**MCPB**  
Item No.  
Date: 10/28/21

## **Pike and Rose Phase II Site Plan Amendment 82013012G**

### **Description**

Figure 2: Building 9 Site Plan

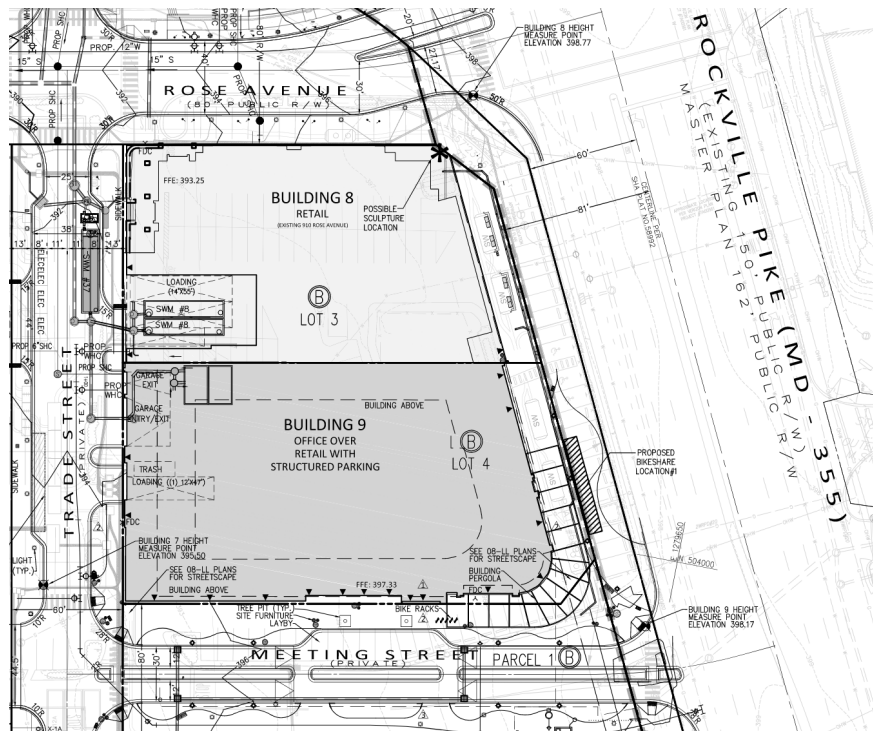
The Subject Site Plan Amendment proposes to change the architectural design and massing of Building 9, a previously approved office building. The change to building design and massing results in a decrease in gross floor area and height from the previously approved building design. Building 9 was originally approved for up to 333,500 square feet of commercial development and a height of 288 feet. The newly designed Building 9 contains approximately 297,500 square feet of commercial development, with 287,500 square feet dedicated to office space and 10,000 square feet of street-level retail. This Amendment also includes changes to the parking for Building 9. Previously, Building 9 was approved to have 372 above-grade parking spaces. The newly designed

Building 9 will have structured parking, containing 282 below-grade parking spaces in three floors of underground parking, and 243 above-grade spaces in four floors above-grade.

Figure 3: Meeting Street Configuration Changes, with Previously Approved in Black and New Proposal in Red

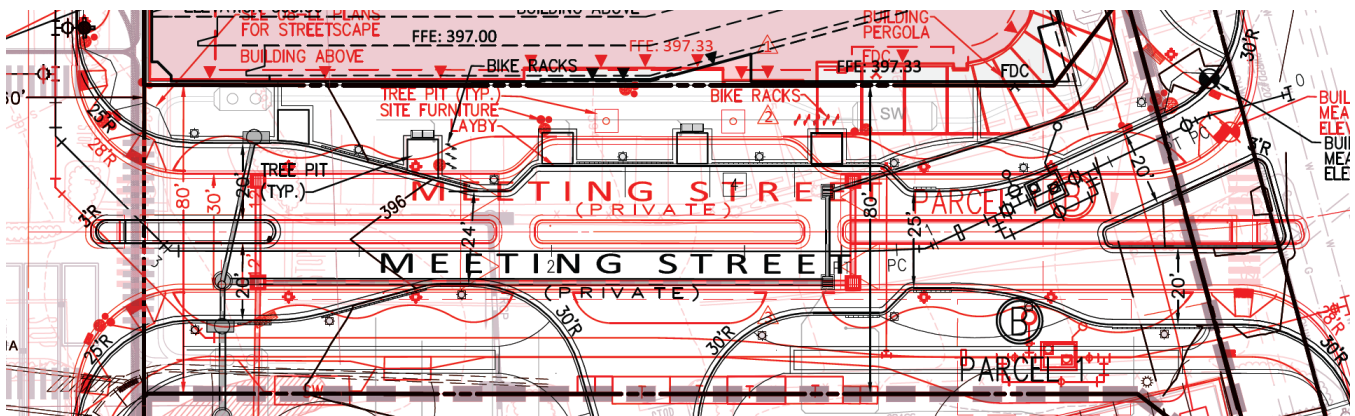
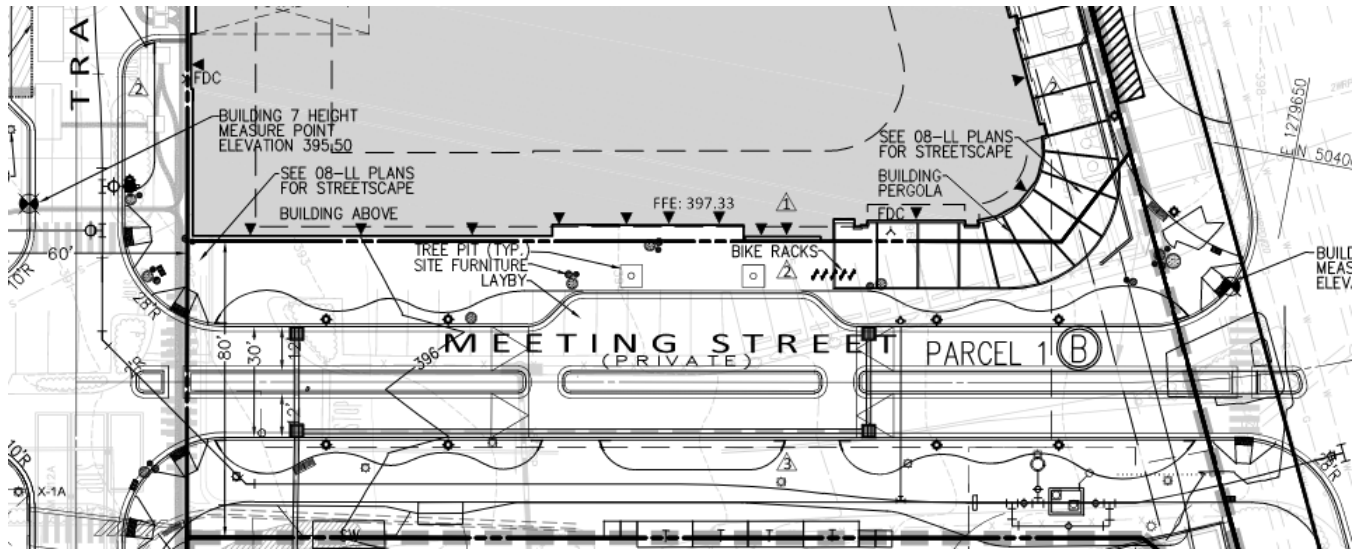
The Amendment also proposes to make modifications to the edge condition on the north side of Block 13 to eliminate an entrance to Meeting Street. Previously, Meeting Street, a private road, was to have an access point onto Block 13. The new configuration eliminates this access point and straightens out the curb along the south side of Meeting Street. The north side of Meeting Street will also be straightened out and will include a layby area at the middle of the block.

Figure 10: Rockville Pike Sidewalk Cross Section

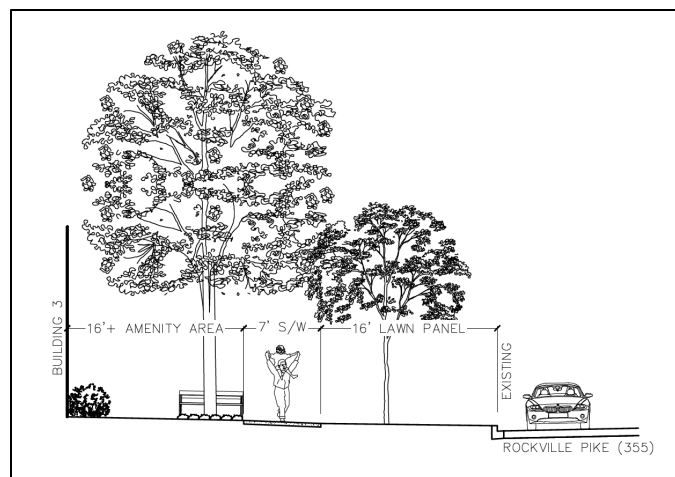
**Rockville Pike (MD 355):** The segment of Rockville Pike between Montrose Parkway and Meeting Street is classified in the *White Flint Sector Plan* and *Master Plan of Highways and Transitways* as M-6, a major highway with planned Bus Rapid Transit service. The segment is currently 150 feet wide and planned to be 162 feet wide with six (6) divided travel lanes and two (2) bus-only lanes. Public right-of-way dedication was provided in support of this requirement through previously approved Preliminary Plan Amendment No. 12012002A and Plat 24860. The MD 355 South Bus Rapid Transit Corridor is planned to travel in dedicated transit lanes along this portion of its overall route. As indicated in Figure 8, the Rockville Pike property frontage will be enhanced with a 16-foot amenity frontage area, 7-foot sidewalk, and 16-foot street buffer in accordance with the streetscape requirements in the *White Flint Urban Design Guidelines*. Implementation of the bi-directional bikeway along the entirety of the Rockville Pike frontage will occur as part of the future Transit service capital project (MD 355 South BRT project), and the placement of the proposed structure will not preclude its construction.
